Kansas Department of Agriculture
 Division of Water Resources
CHANGE: P/U WORKSHEET
Ownership Change

RE: Water Right File No(s). 1660, 31754 &
42234

Water Right, File No. 1660

Change in P/U Application Map 36-28-1W // Sedgwick County

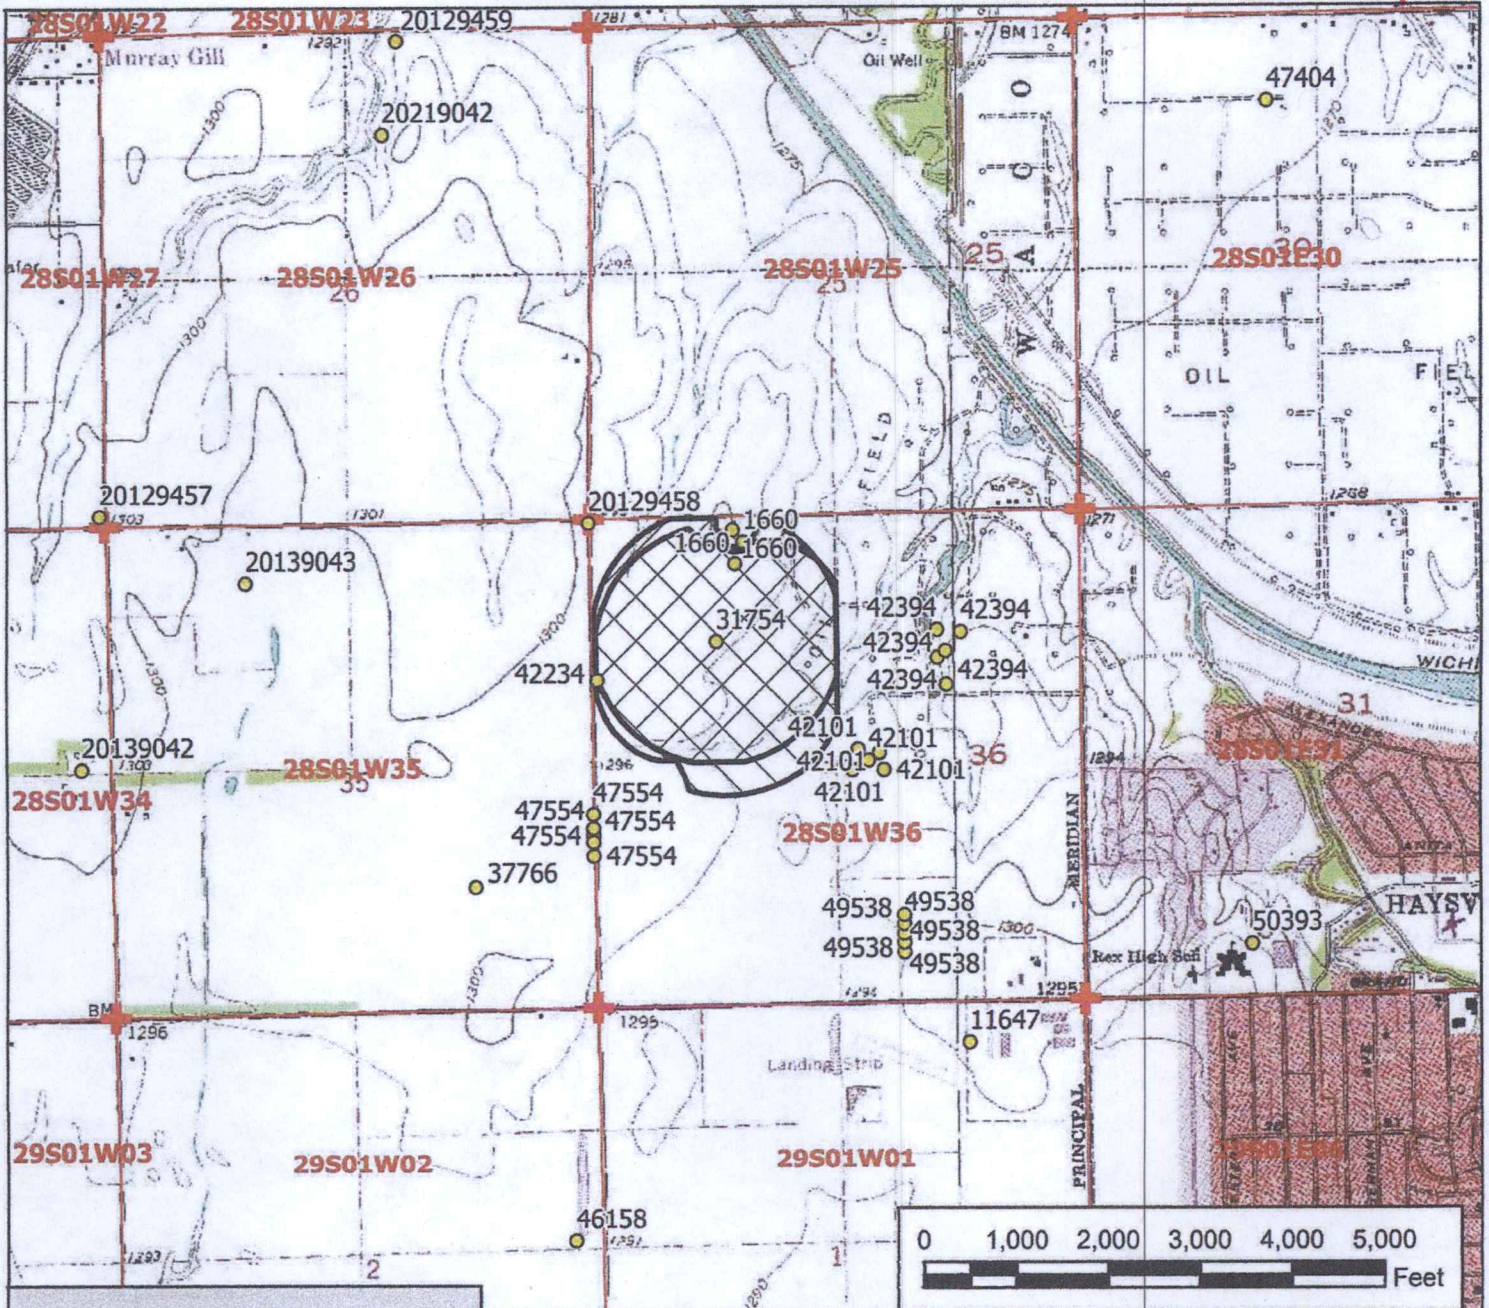
The referenced change applications, received on August 9, 2021, propose to maintain the existing overlap under the associated water rights while modifying the acreage to authorize additional acres to accommodate a swing arm center pivot system.

File No. 5228 has 128 "Base Acres" as defined by K.A.R. 5-5-11 *Applications for change in place of use for irrigation purposes*. File No. 31754 and 42234 do not have any additional base acres. The proposed 138 acre place of use complies with part (b) of K.A.R. 5-5-11 and the 10 acre / 10 percent increase above the *Base Acres* is allowed by the regulation.

The proposed changes will result in a maximum quantity of 153 AF irrigating 138 acres, resulting in an irrigation ratio of 1.11 AF per acre. It would appear this irrigation ratio is reasonable as the ratio is less than the 1.5 AF per acre maximum for Sedgwick County found in K.A.R. 5-3-19, *Maximum reasonable annual quantity of water for irrigation use*, thus complying with K.A.R. 5-3-23, *Maximum reasonable annual quantity approvable for irrigation use for an application for change in place of use and a request to reduce a water right*. The generally accepted minimum quantity per acre for Sedgwick County is 1.05 AF per acre, so the proposed quantity meets this threshold as well.

2. On and after the effective date of this summary order, the authorized place(s) of use shall be located substantially as shown on the topographic map accompanying the application to change the place of use. Applicable Not Applicable
